BYLONG COAL PROJECT

Environmental Impact Statement Supplementary Response to Submissions

August 2016

SUPPLEMENTARY RESPONSE TO SUBMISSIONS

Figure 2. Box Gum Woodland and Derived Native Grassland mapping within the Project Disturbance Boundary

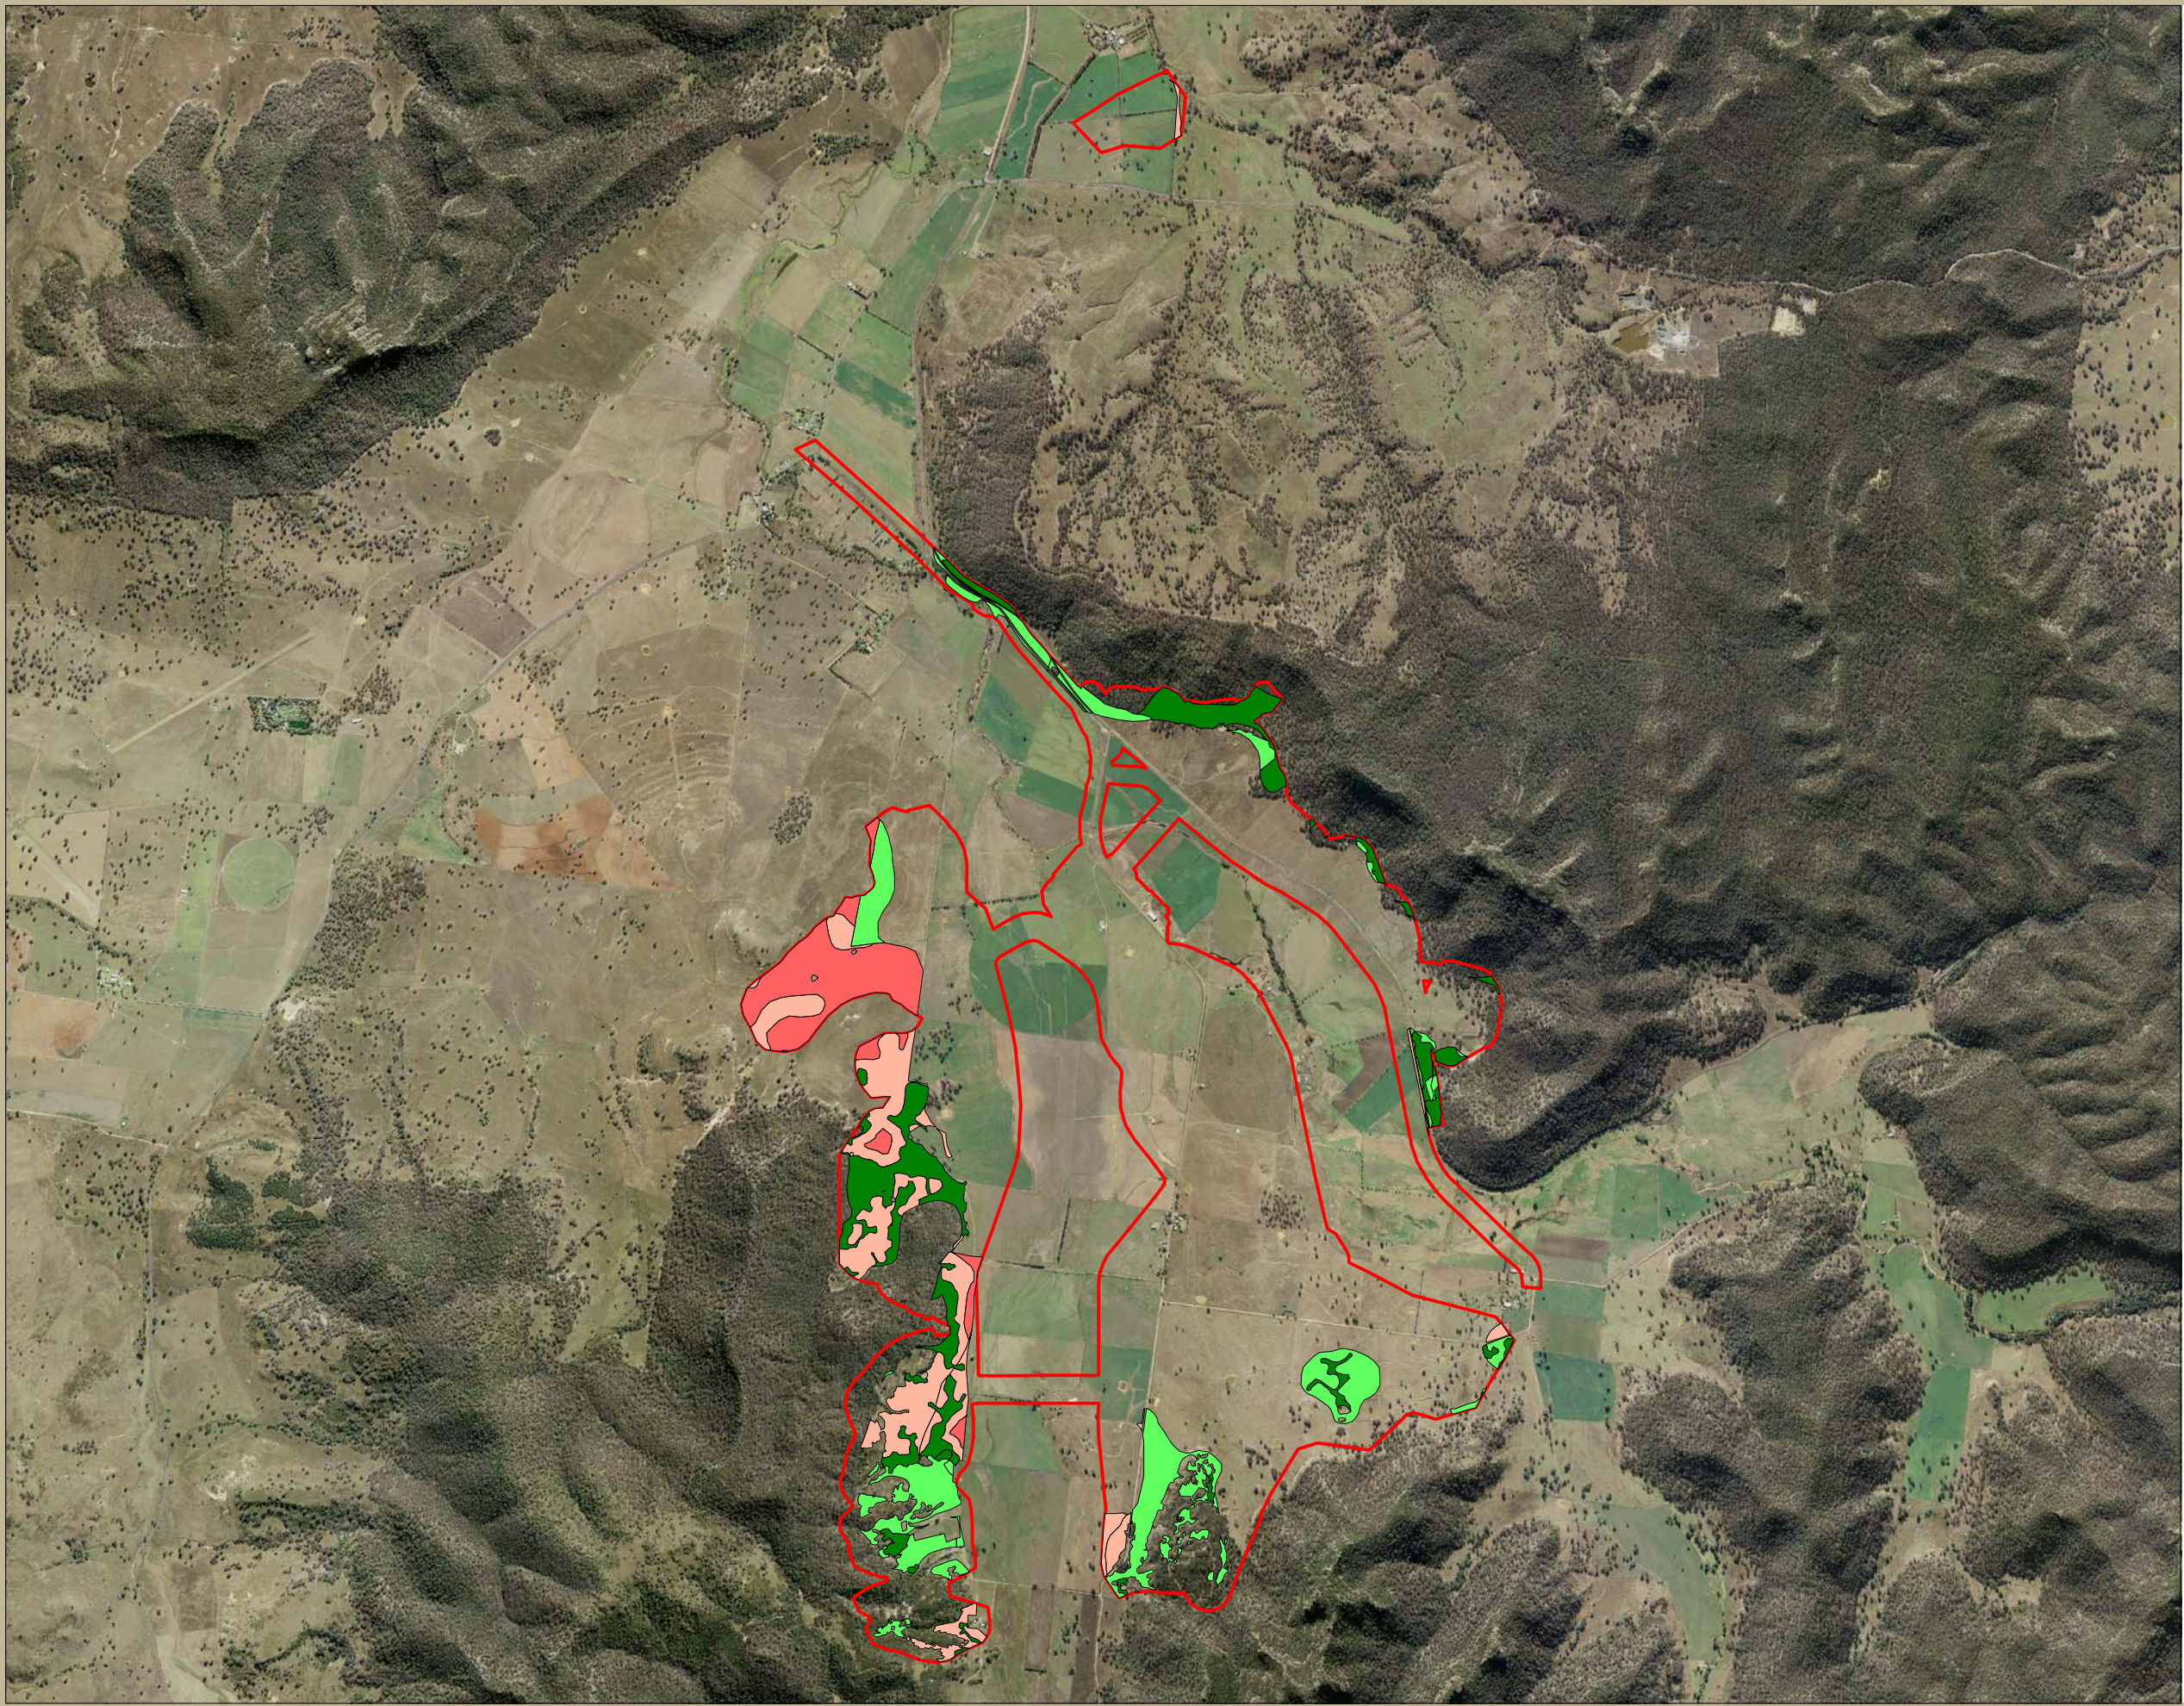
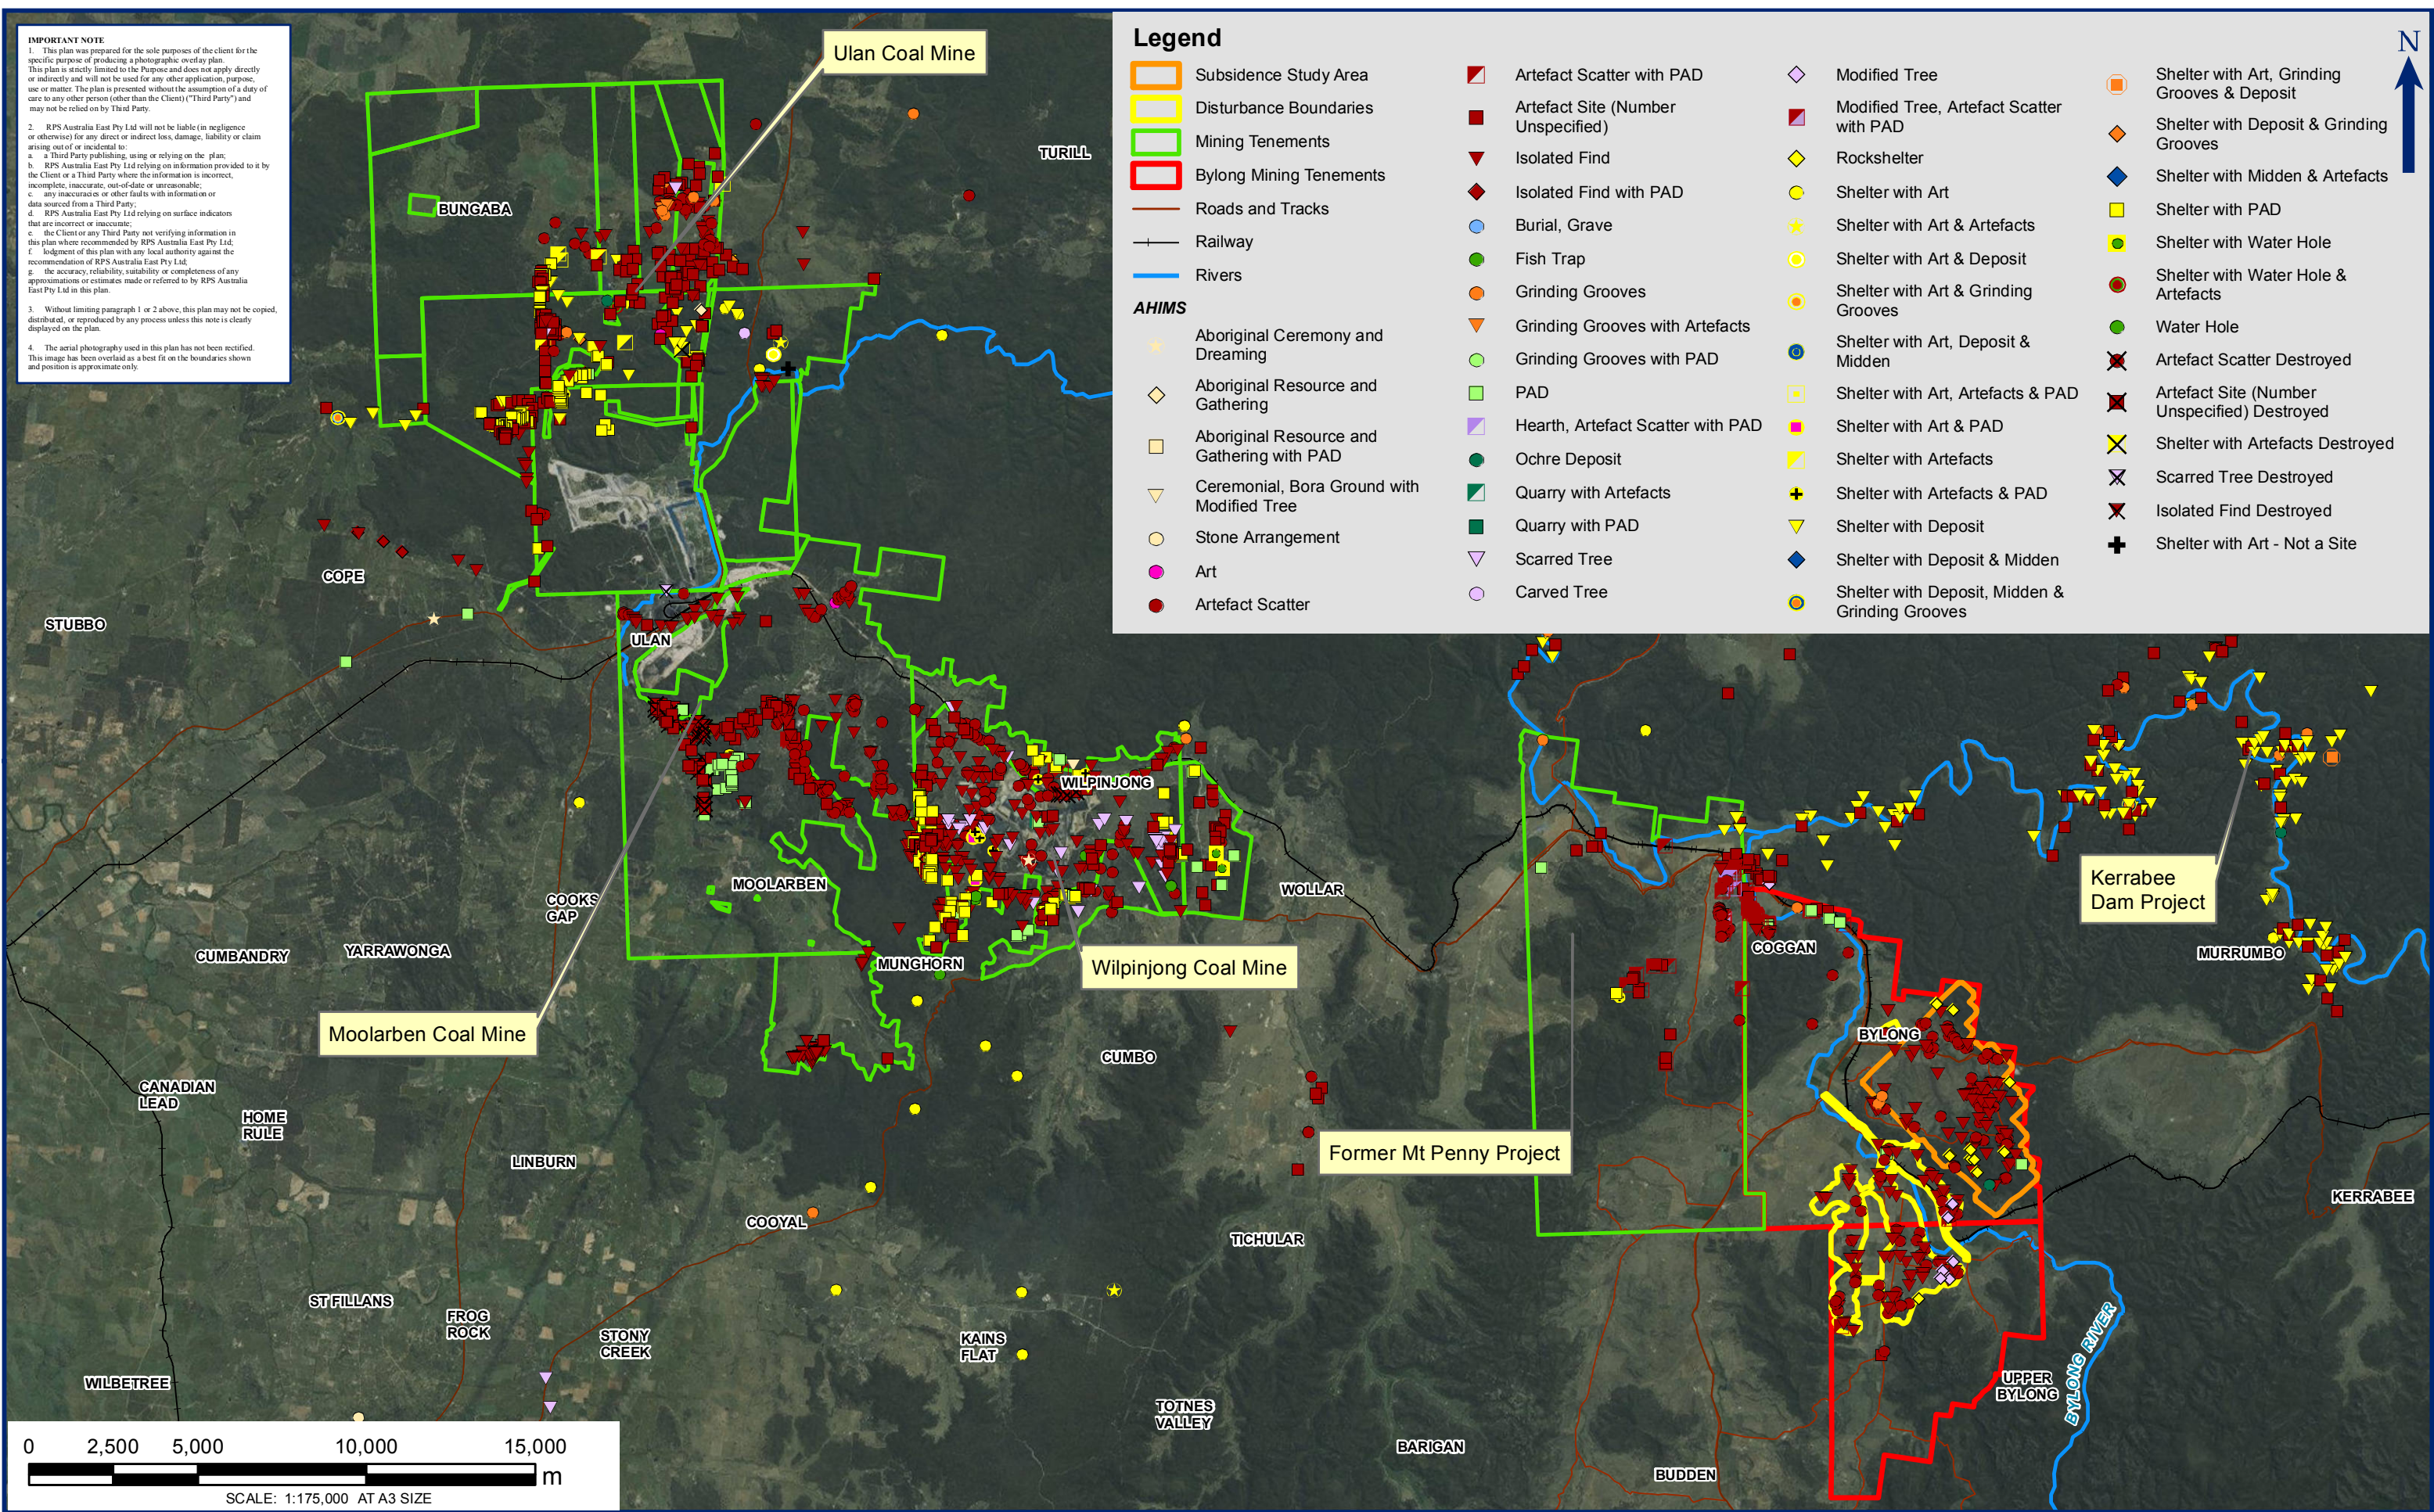
6.	Ecology – Category 2 and Category 3 Grassland Mapping	Appendix B	<ul style="list-style-type: none"> KEPCO provided a response to OEH's letter dated 14 March 2016 in correspondence dated 12 May 2016. During meeting on 16 June 2016, Commonwealth Department of the Environment (DoE) requested the inclusion of grassland conforming to category 2 and category 3 grasslands within the mapped extent of Box Gum Woodland and Derived Native Grassland.

Issue Ref	Issue	Appendix	Response Summary
			<ul style="list-style-type: none"> The revised mapping of the EPBC Act Box Gum Woodland and Derived Native Grassland community reflecting DoE's requests illustrates approximately 68 ha of Category 2 grasslands and 43 ha of Category 3 grasslands. This revised mapping illustrates a total of approximately 249 ha of EPBC Act Box Gum Woodland and Derived Native Grassland community within the Project Disturbance Boundary as per DoE's request.

Figure 1

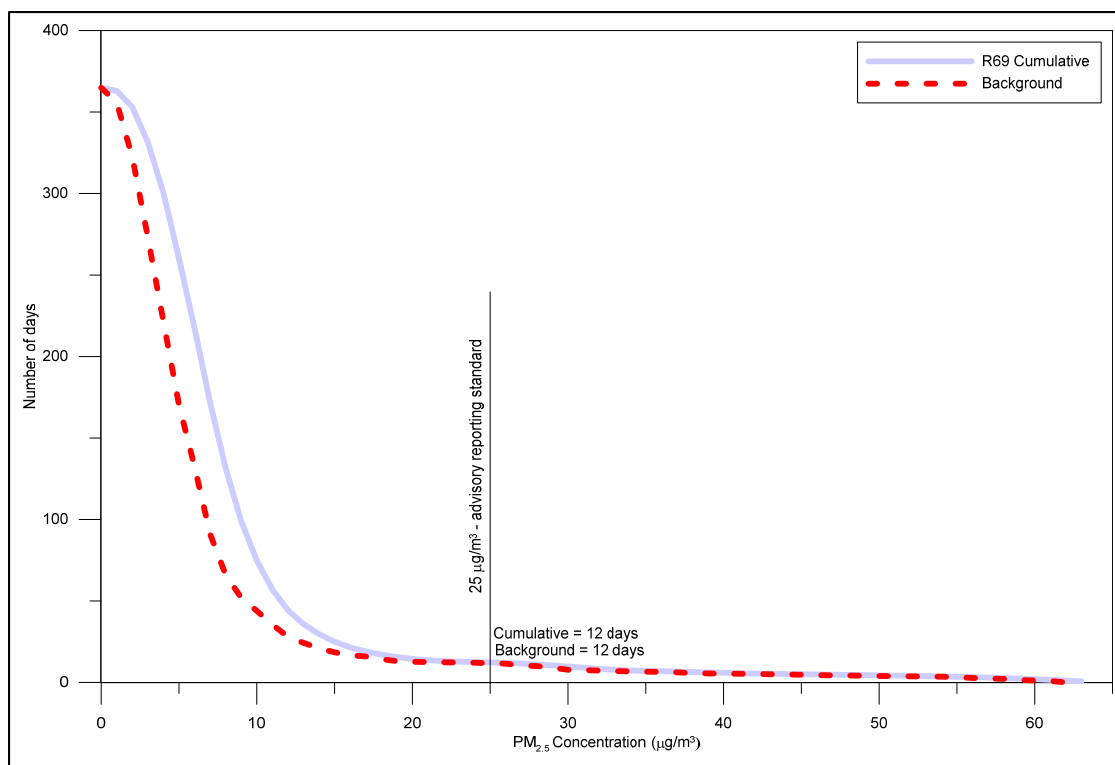
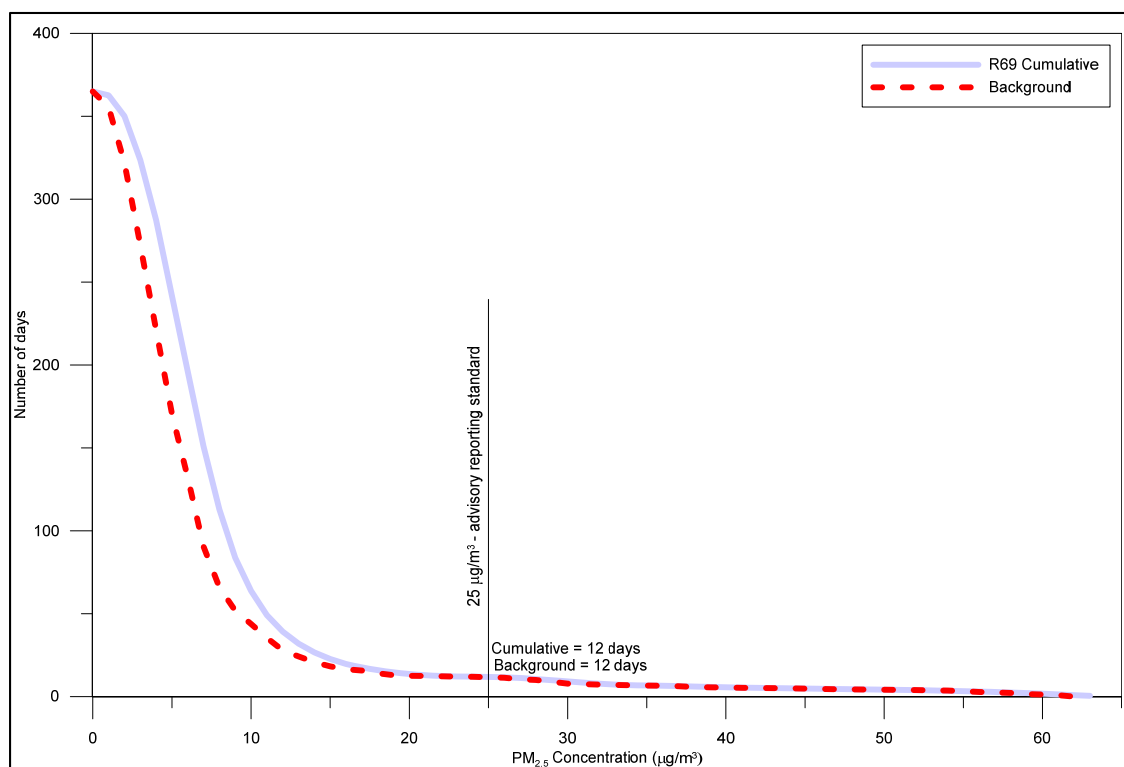
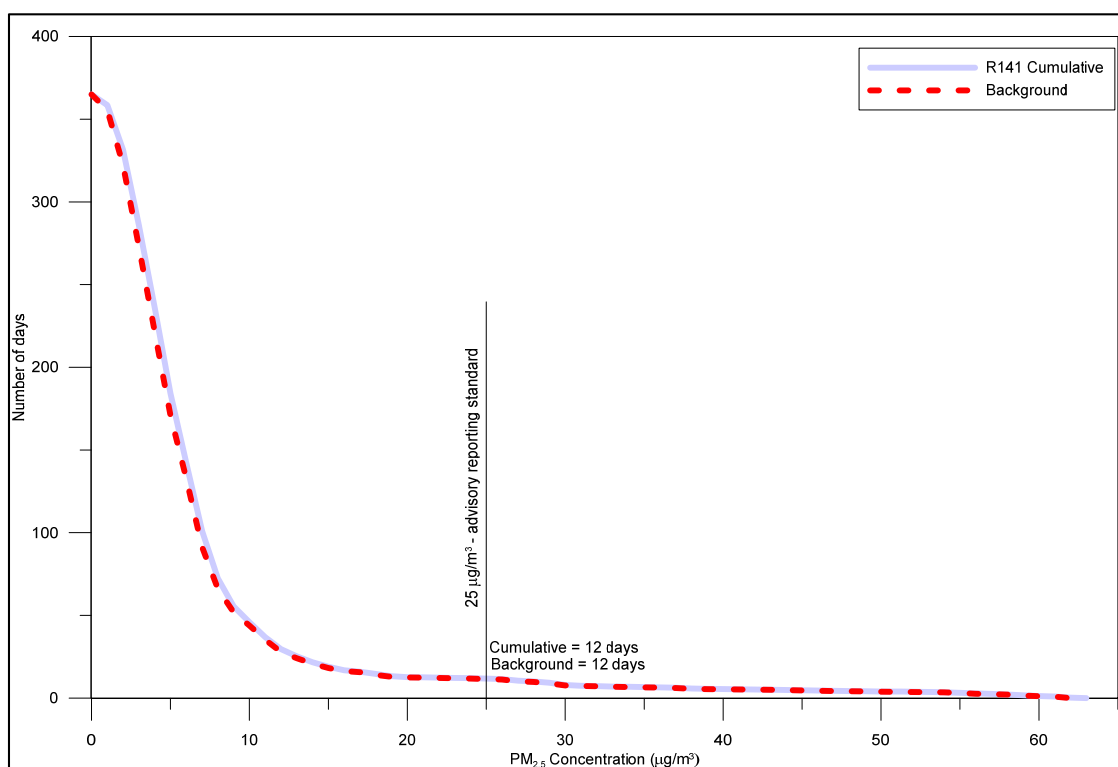
The exhibited air quality assessment estimates total PM2.5 emissions (year 3) at approximately 13% of estimated PM10 emission. On this basis, where analysis is presented as a function of proportional emission change, the proportional change for PM2.5 emissions is likely to be much larger than the estimated change in PM10 emissions presented in the RTS.

Figure 1 to Figure 3 show the predicted cumulative 24-hour PM_{2.5} concentration for receiver 69 compared with the existing background for Years 3, 5 and 9 of the Project respectively. These figures demonstrate that there is a very low probability for the occurrence of any additional days where cumulative PM_{2.5} concentrations would be greater than the relevant criteria. Further, there are no additional days predicted to exceed the 24-hour standard than that shown in the AQGHGIA (Appendix O of the EIS).

Figure 4
C - A Weighting Difference Compared to Hearing Threshold

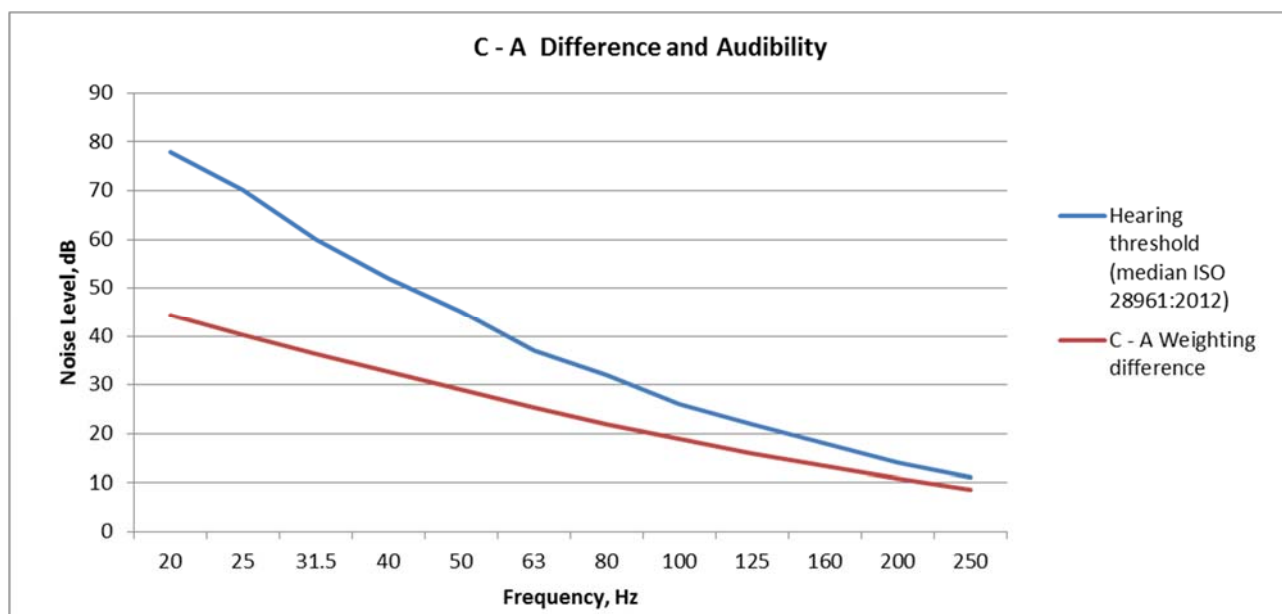
The NSW INP overall C - A weighted approach to determining a penalty for low frequency noise can potentially over estimate low frequency noise impacts due to the human hearing threshold of audibility and distance attenuation of sound.

When comparing the difference between the A and C weighting curves with the threshold of audibility at low frequencies (below 250 Hz), it becomes apparent that a difference greater than 15 dB(A) can readily occur without audibility of the noise. This is shown in **Figure 4**.
